Mack - North Phase (49-DR-2022#2)  
**Summary of Updates from Prior Submittal**

# MACK INNOVATION PARK

PHASE 1 - North

SEC of Loop 101 and Pima Road  
Development Review Application  
Application 49-DR-2022#2

**DR24-B**

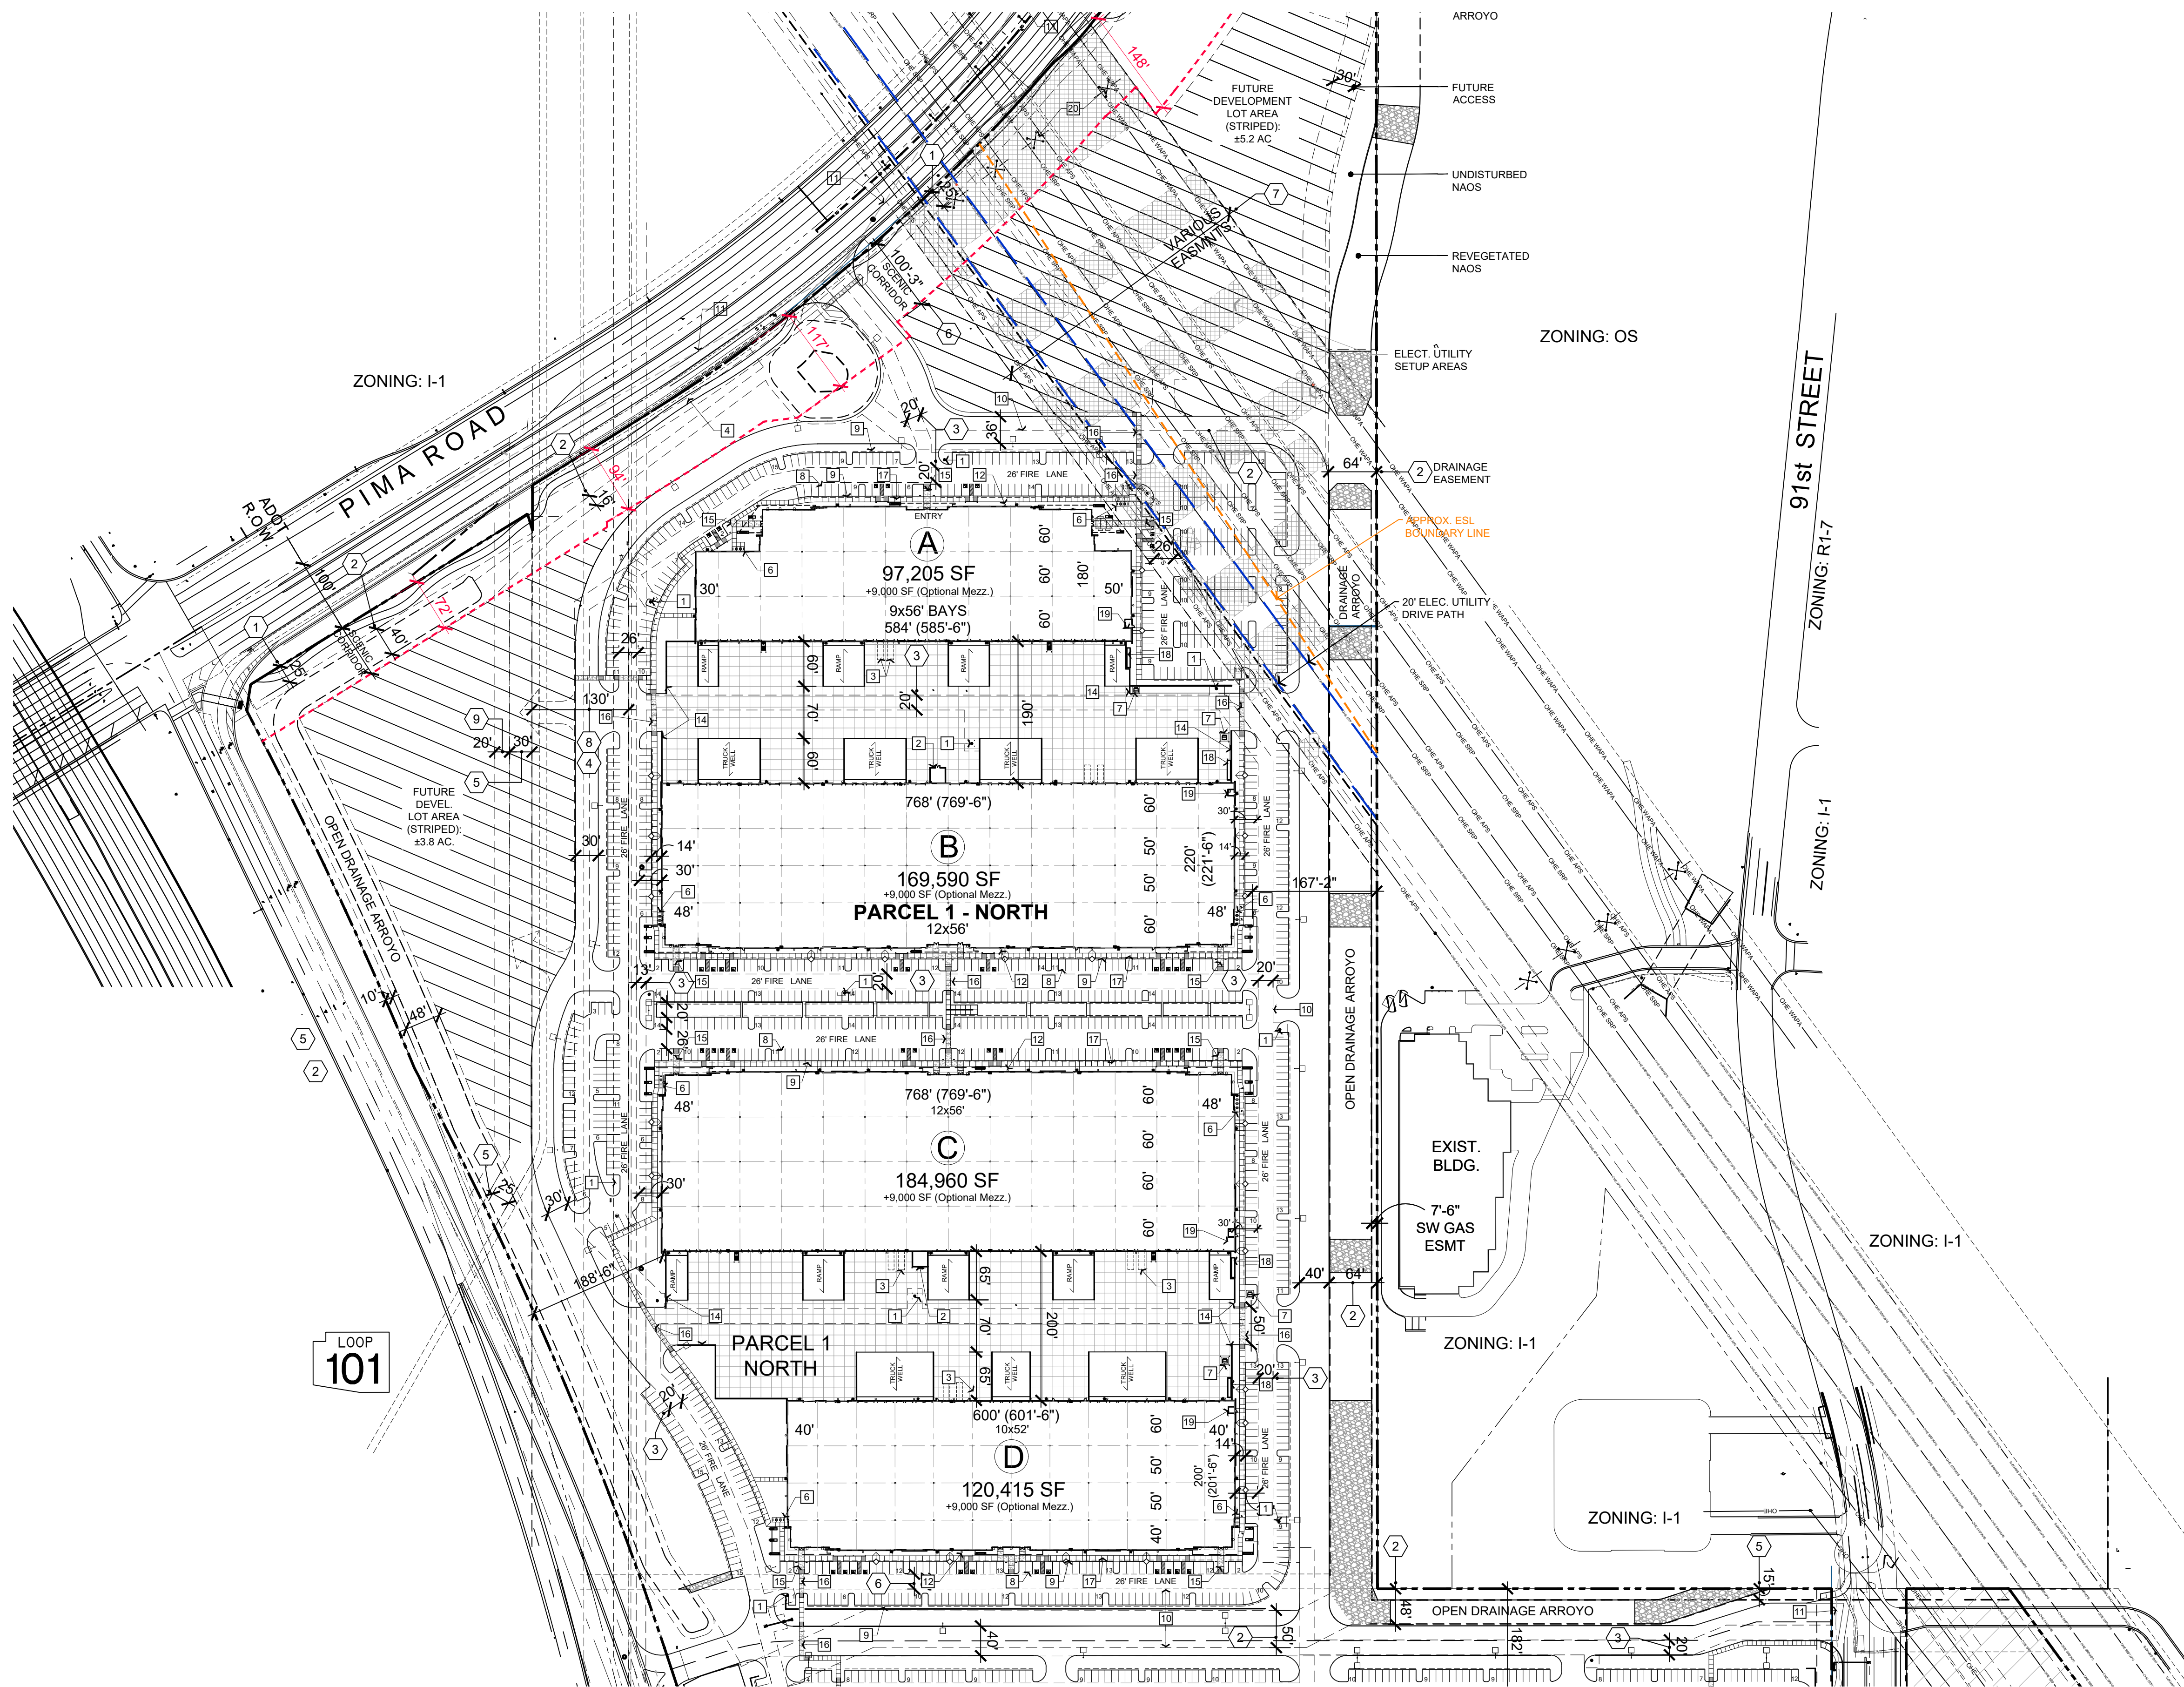
DR24 Updated Master, Enlarged and Color Site Plans

- Revised Site Gross and Net area summaries for entire Site and calculates proposed Buildable Area and Parking for each parcel
- Includes updates to drainage plan, Scenic Corridor and I-1 / ESL area

**1 BLDG A - NORTH ELEVATION**  
SCALE: 1" = 30'-0"

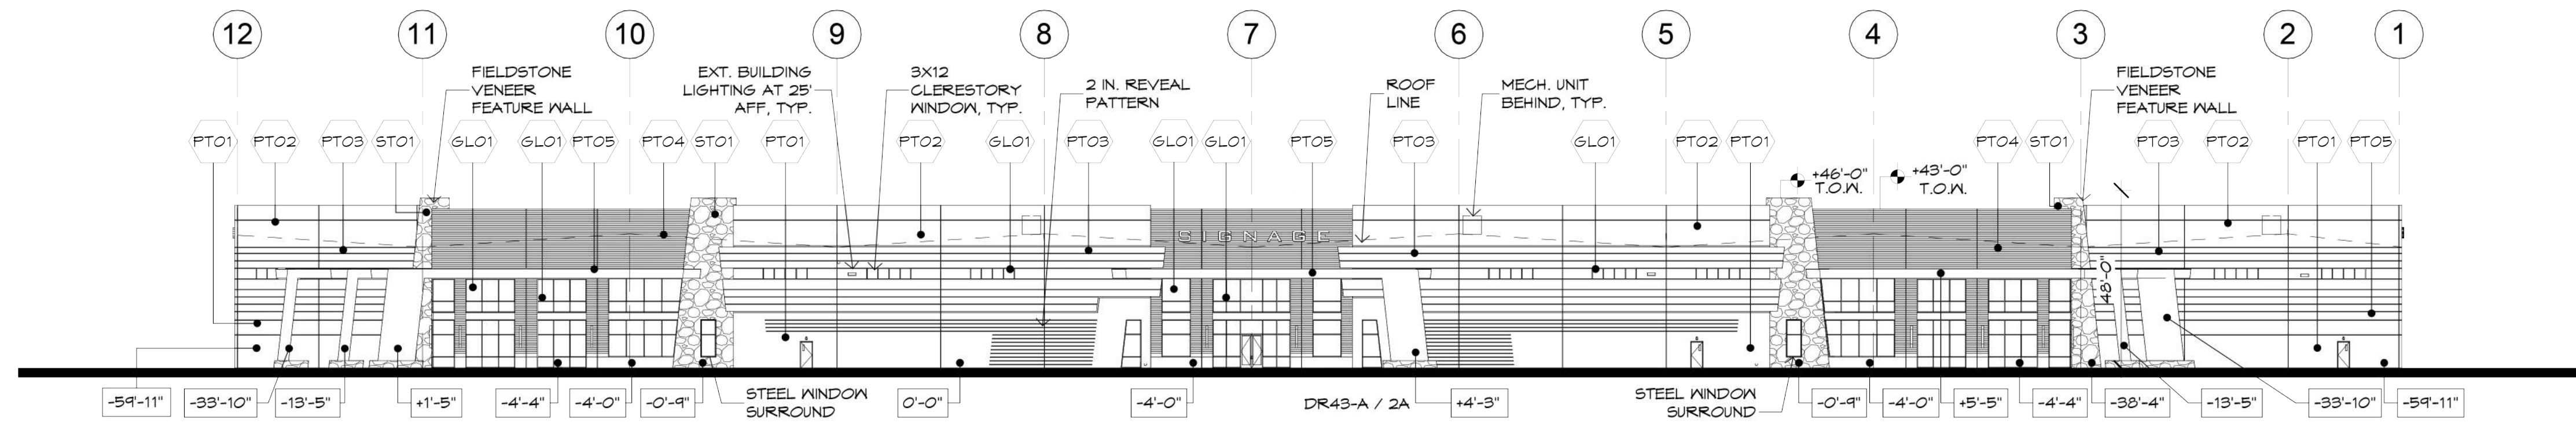
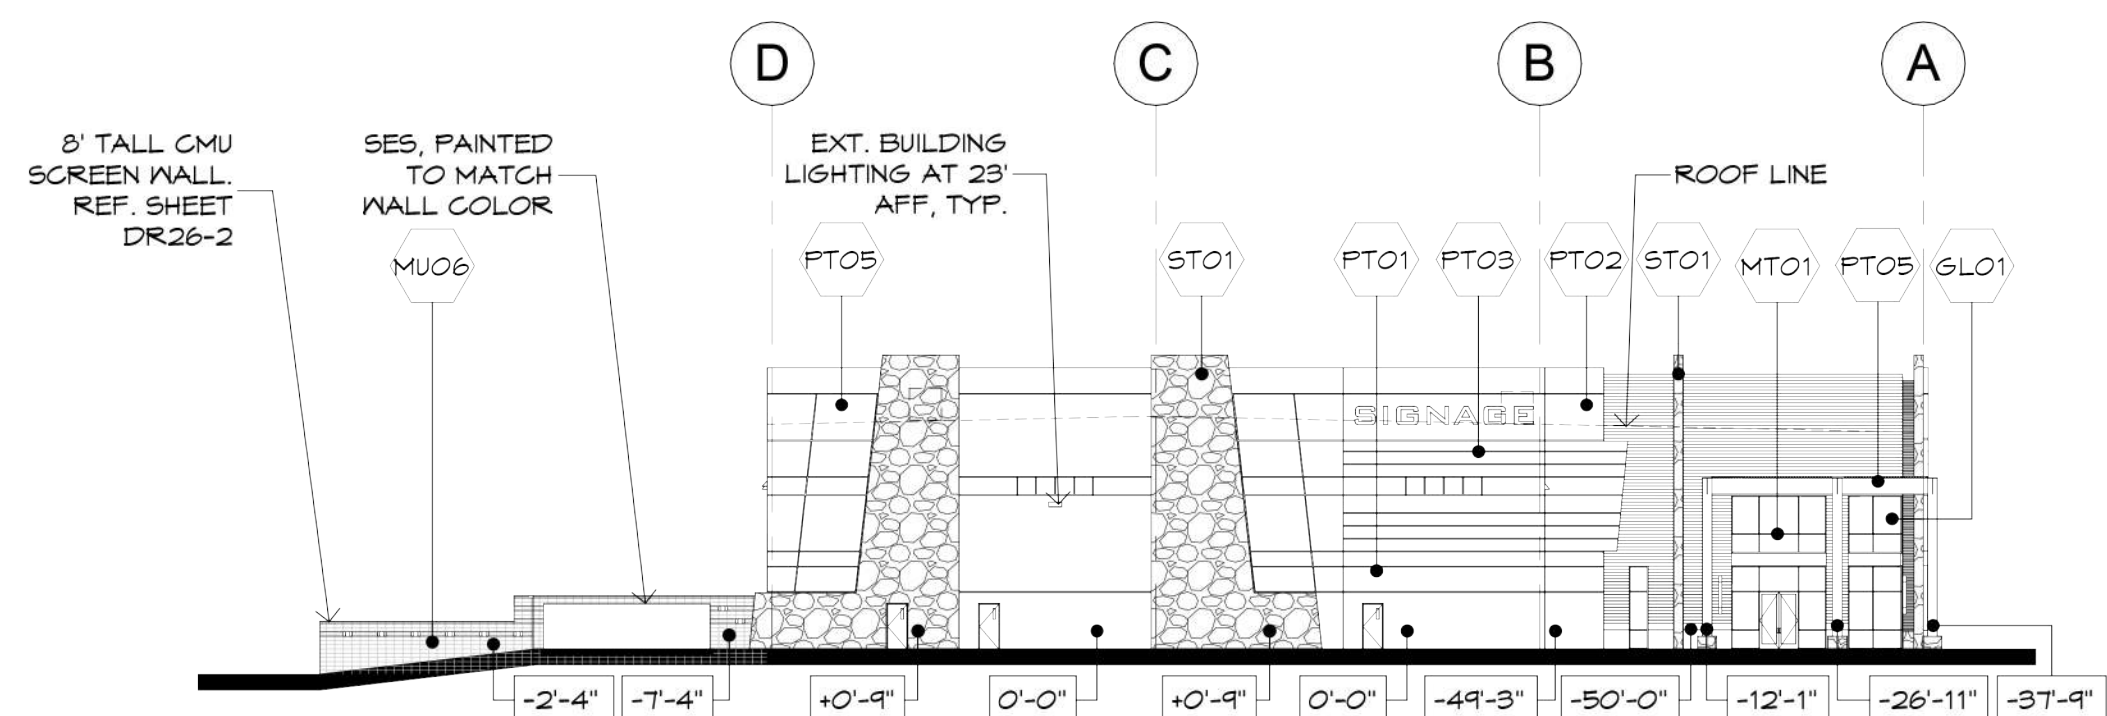
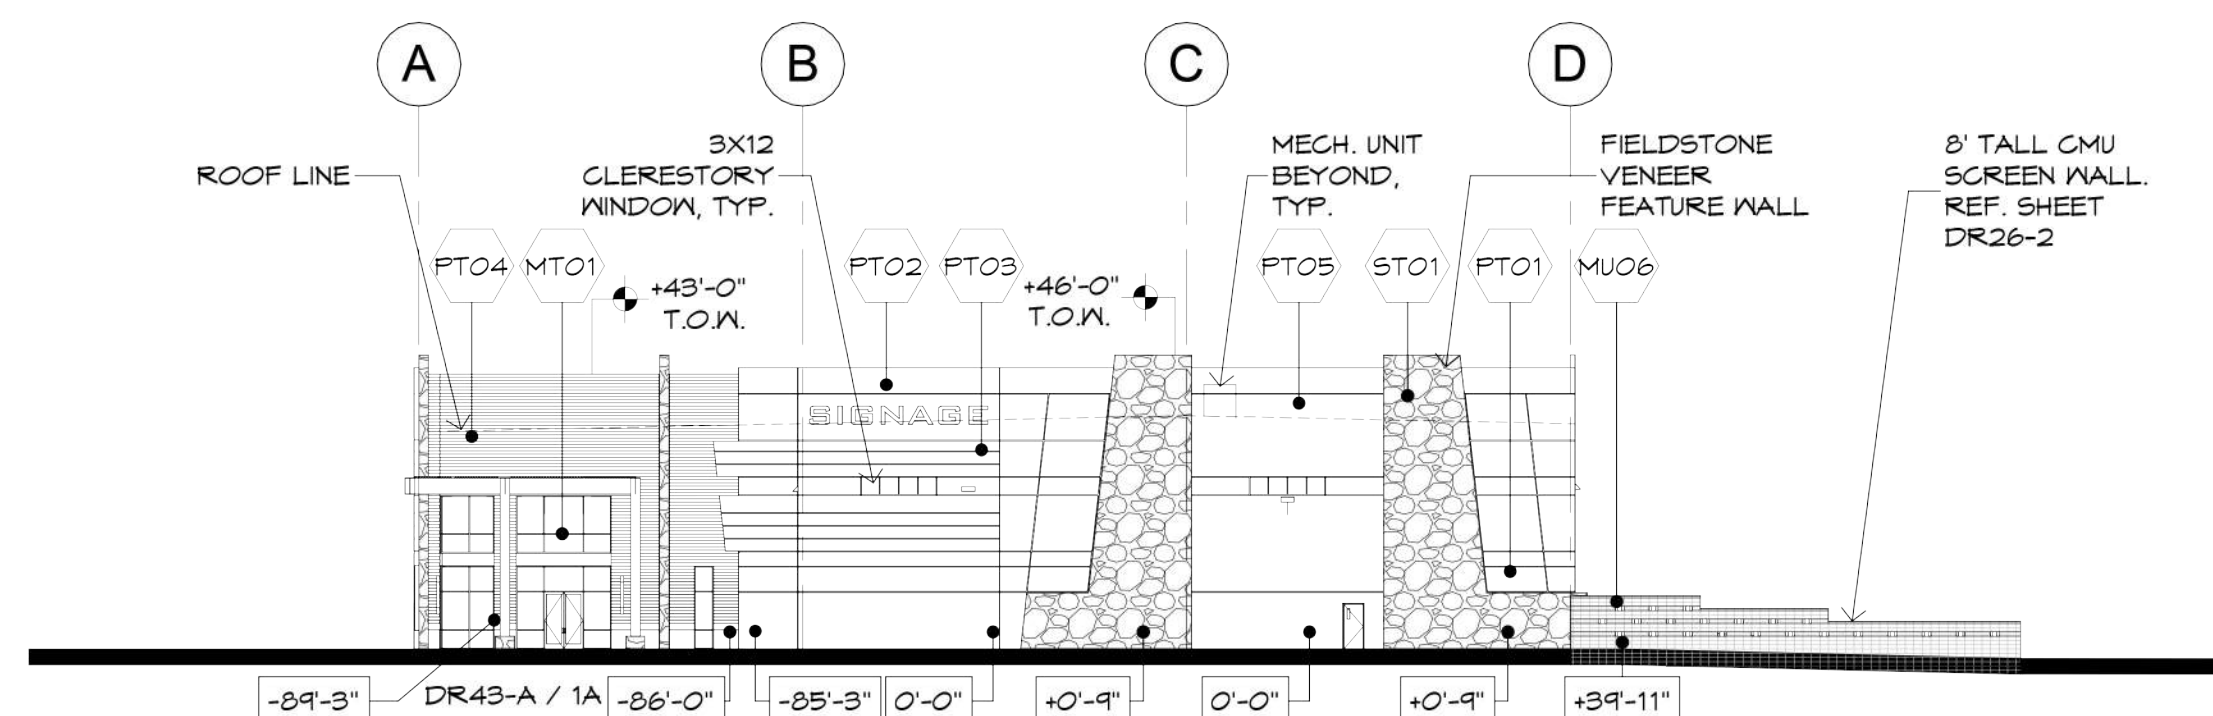
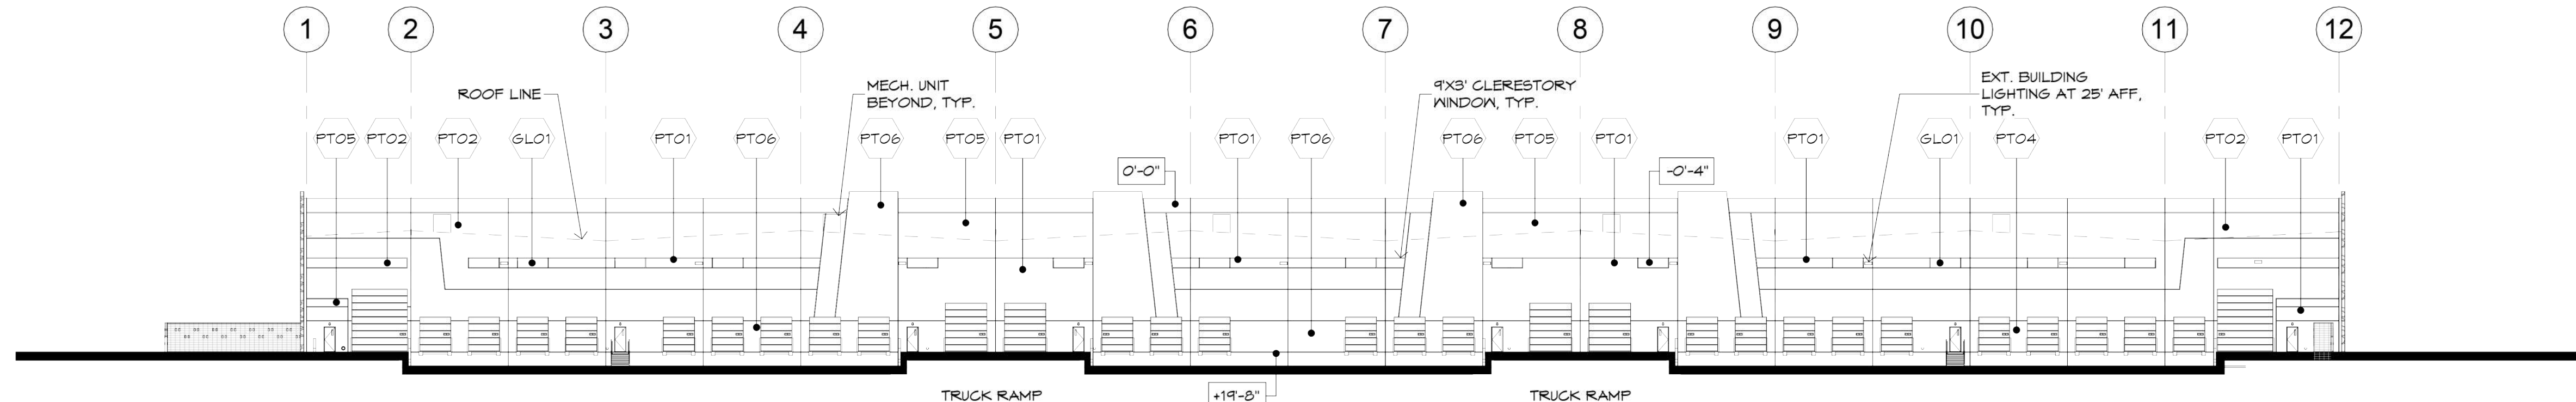
DR39 Revised B&W and Color Elevations

- Updated to show revised building exterior colors and loading dock elevations with added architectural details
